ZONING 2001-016C (MX-3 Innovative)

STAFF RESOURCE: John Kinley

REQUEST:

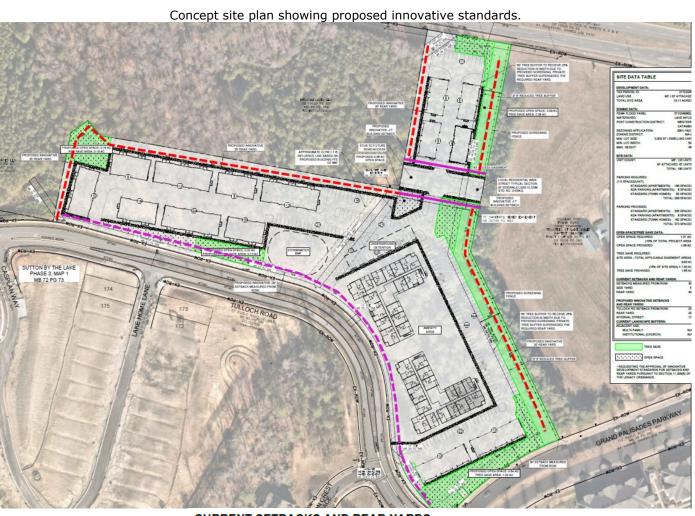
- 20 ft rear yard, based on building orientation (20 ft reduction) (red dash line on image below)
- 20 ft front setback along Tulloch Rd. (10 ft reduction) (magenta dash line on image below)
- 17 ft front setback along internal network required street (13 ft reduction) (magenta solid line on image below)

- The parcel is shaped like a Y which creates odd building/development envelopes. The proposed reduced rear yard allows a more efficient layout and compact design within the TOWN CENTER area of the Palisades.

- Along the eastern property line, abutting the church, a privately agreed upon Tree Buffer of 37.5 ft in width supersedes the proposed reduced 20 ft rear yard.

- The proposed reduced front setbacks support a more compact development placing buildings closer street enhancing the pedestrian experience and pedestrian access to the buildings.

- The standard 30 ft front setback remains for Hwy 49 and Grand Palisades Parkway as they are major thoroughfares.

Staff recommends approval of the Innovative Request.
